Form 3160-5
(February 2005)

SUNDRY NOTICES AND REPORTS ON WELLS
Do not use this form for proposals to drill or to re-enter an abandoned well. Use Form 3160-3 (APD) for such proposals.

5. Lease Serial No. NM-23045
6. If Indian, Allottee or Tribe Name
7. If Unit of CA/Agreement, Name and/or No.
8. Well Name and No. Schalk 31-4 #2
9. API Well No. 30-039-22103
10. Field and Pool or Exploratory Area Blanco Pictured Cliffs
11. Country or Parish, State Rio Arriba, NM

PLUG AND ABANDONMENT PROCEDURE

SCHALK 31-4 #2 Blanco Pictured Cliffs

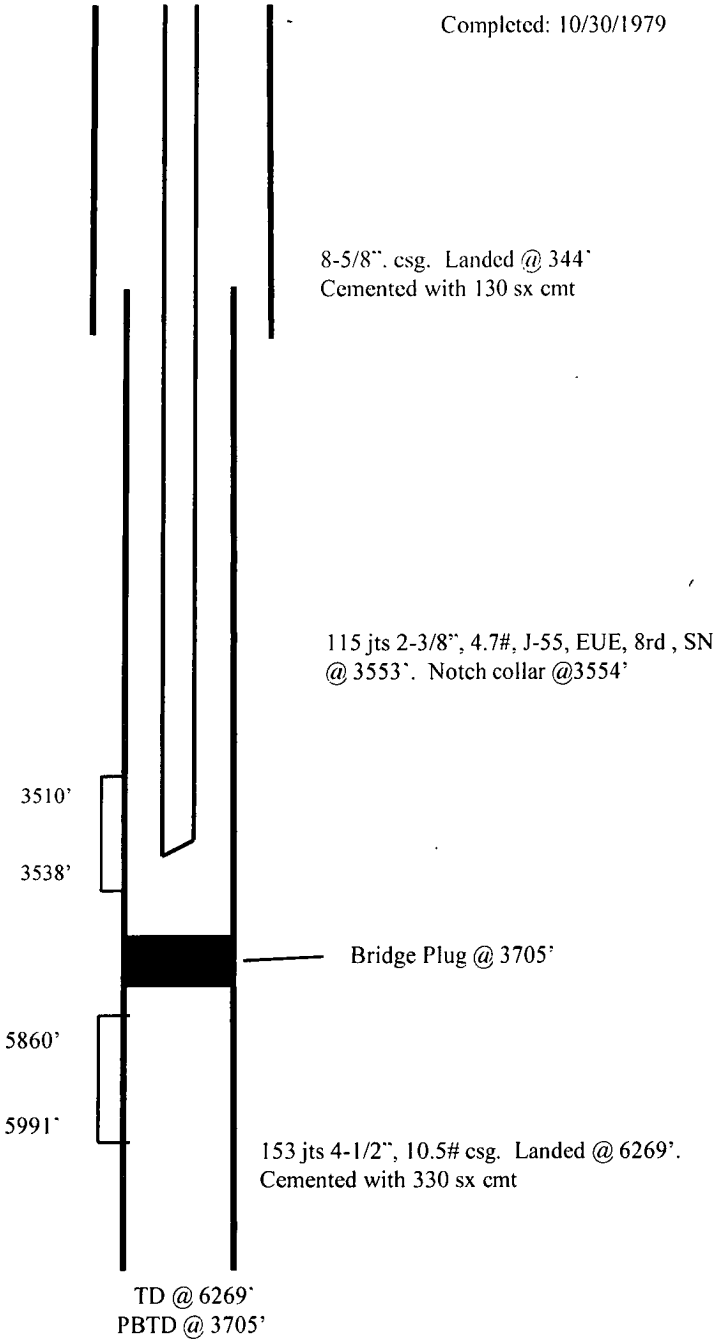
* Extend plug #3 2838'-3510' to isolate the PC as much as possible, a CR is approved if needed. OJO top appears to be at 2888'

Well records have indicated that a cement bond log (CBL) or other cement evaluation tools were not ran in this wellbore. This office has no documentation of where the top of cement (TOC) was found behind the 4.5" production string. **Therefore, the operator must run a CBL to verify the TOC before setting the first plug in this wellbore.**
